CITY OF ALBUQUERQUE

RE: **Lot 3 Block 3 Unit 19 SAD 228
6608 Cuervo Pl. NW
Volcano Cliffs Subdivision
Grading and Drainage Plan
Engineers Stamp Date 12/31/2020 (D10D003S3)**

DRAINAGE AND TRANSPORTATION INFORMATION SHEET (REV 6/2018)

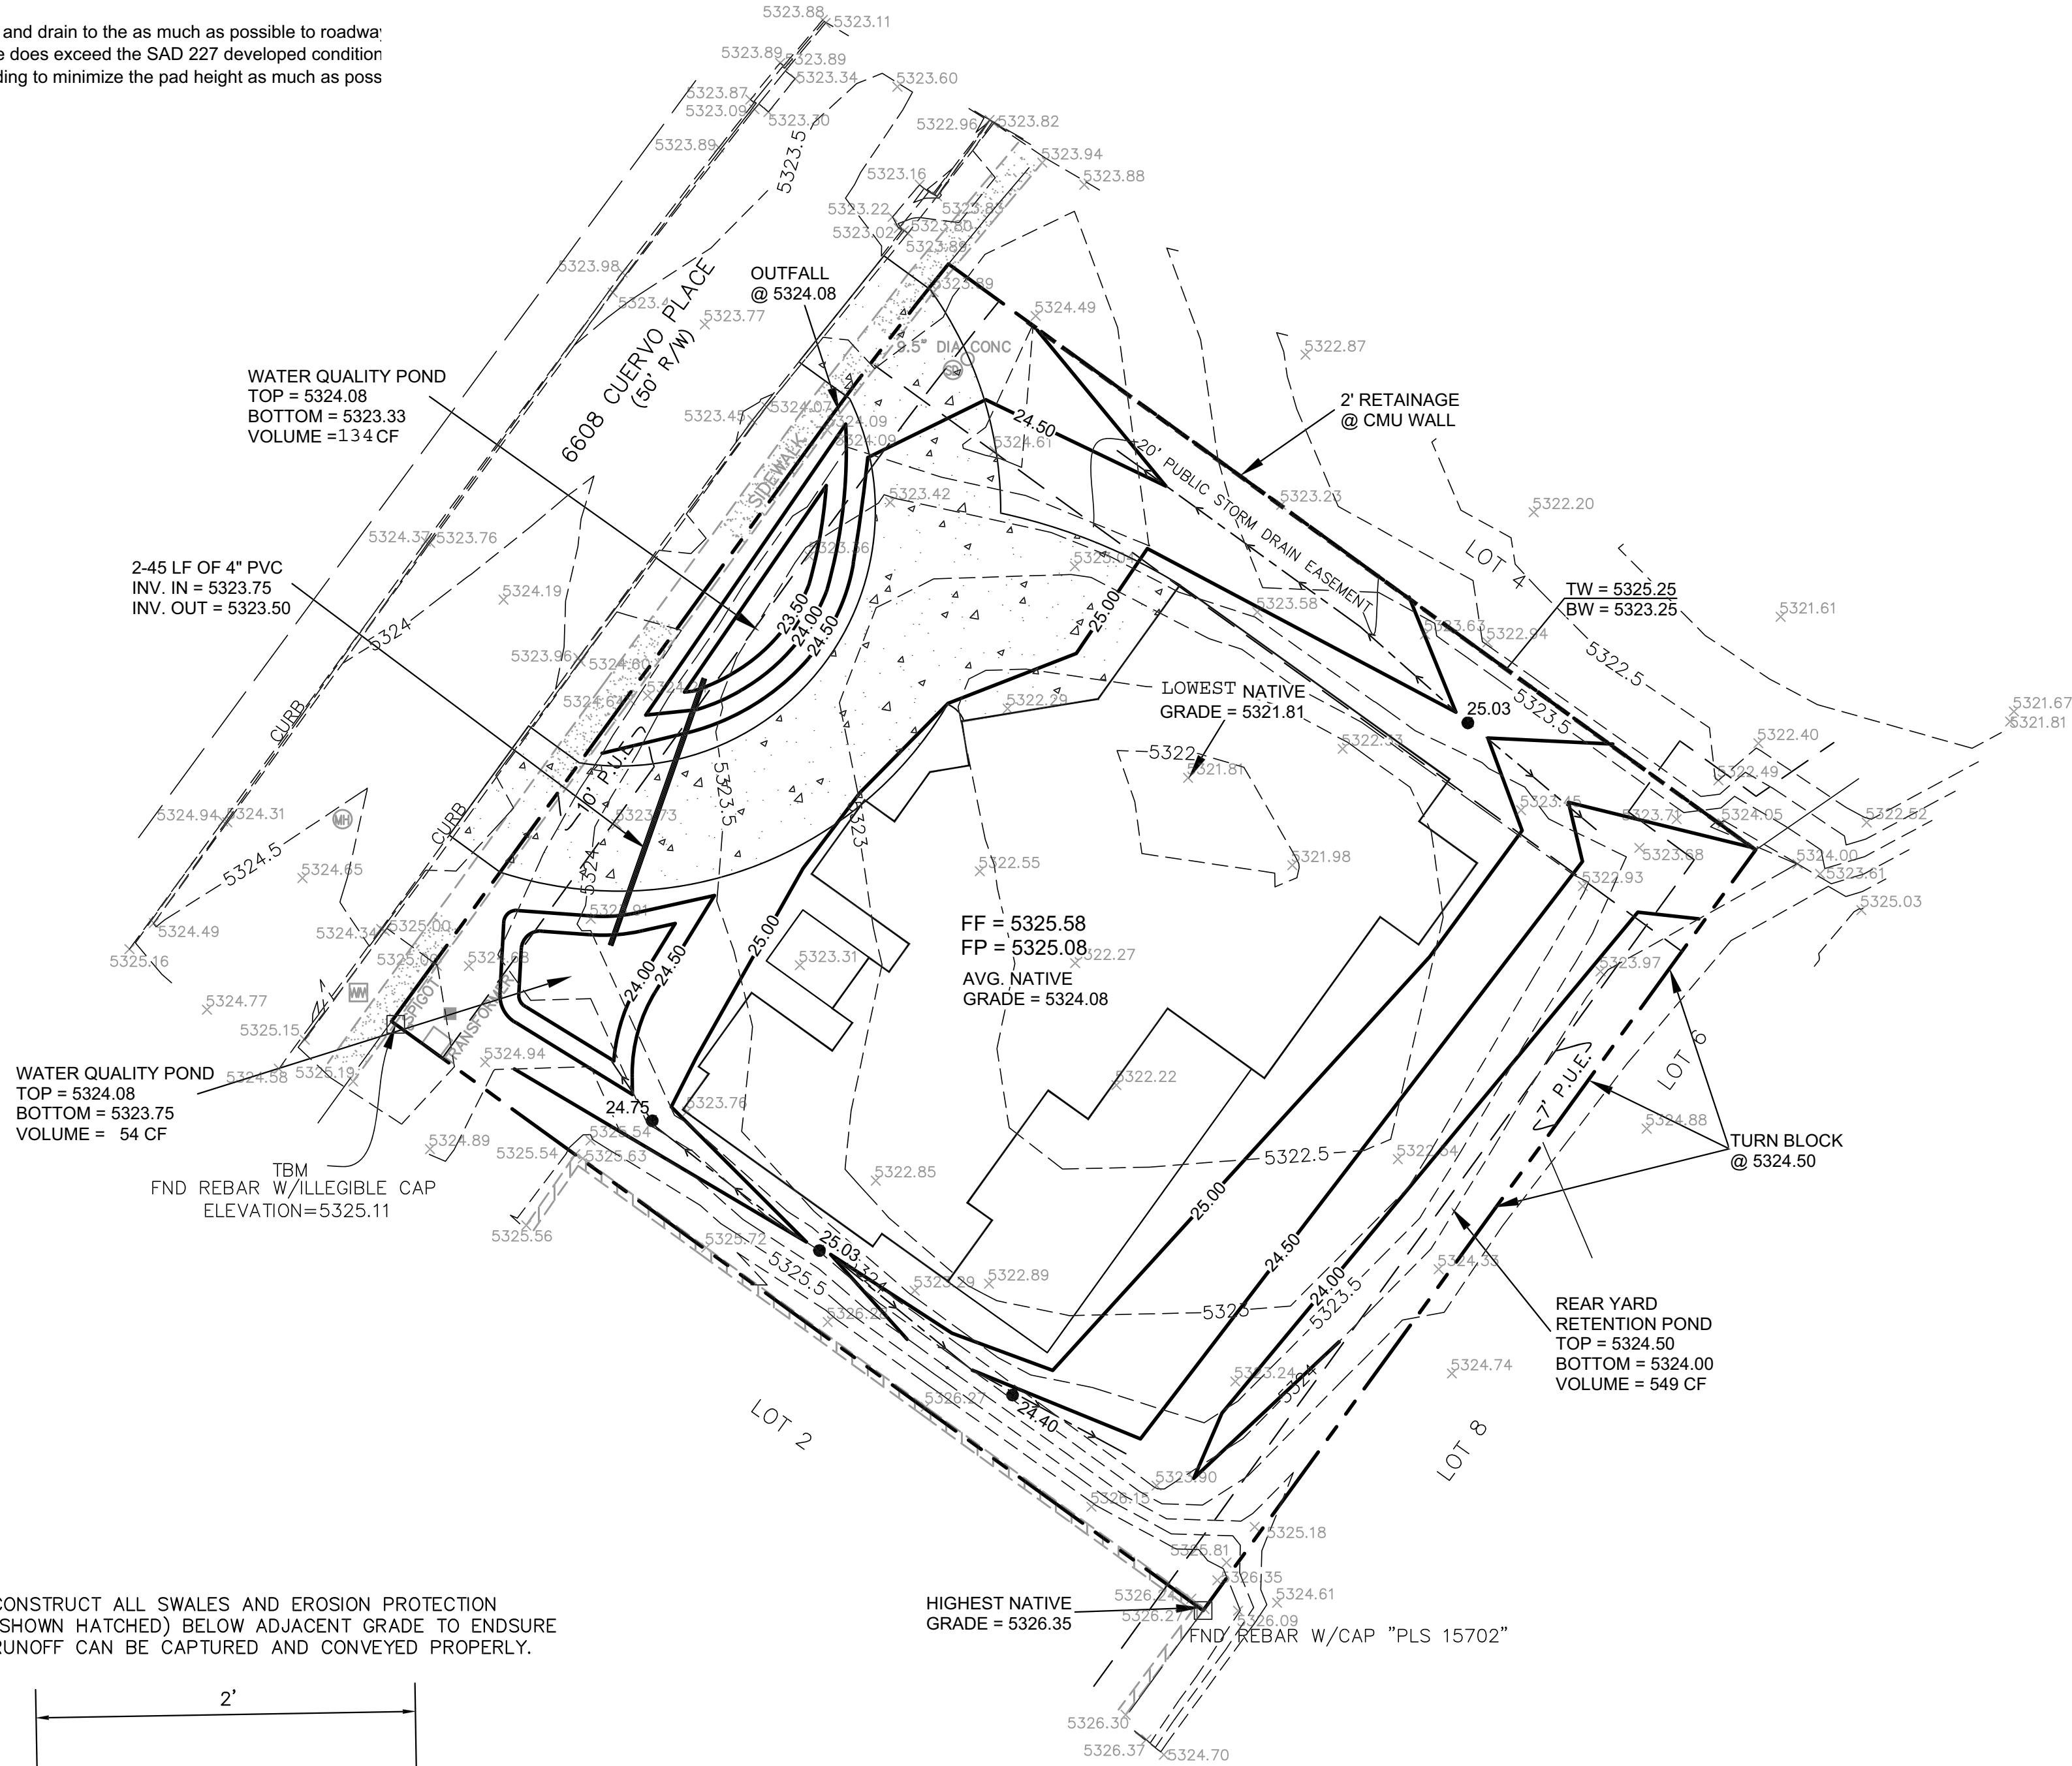
Based upon the information provided in your submittal received 1/4/2021, this plan is approved for Grading Permit.

Prior to Building permit approval a Pad Certification will be required, provided by the Engineer or a registered Land Surveyor.

Advise the owner contractor not to use dirt as a ramp to climb the curb, use lumber or crusher fines for this purpose.

Reiterate to the Owner/Contractor that a separate permit for a garden/retaining wall must be obtained with the approved G&D plan and Pad Certification. Also, if a swimming pool is to be placed the grading and drainage plan will change and will need to be resubmitted.

Prior to Certificate of Occupancy release, Engineer Certification per the DPM checklist is required.
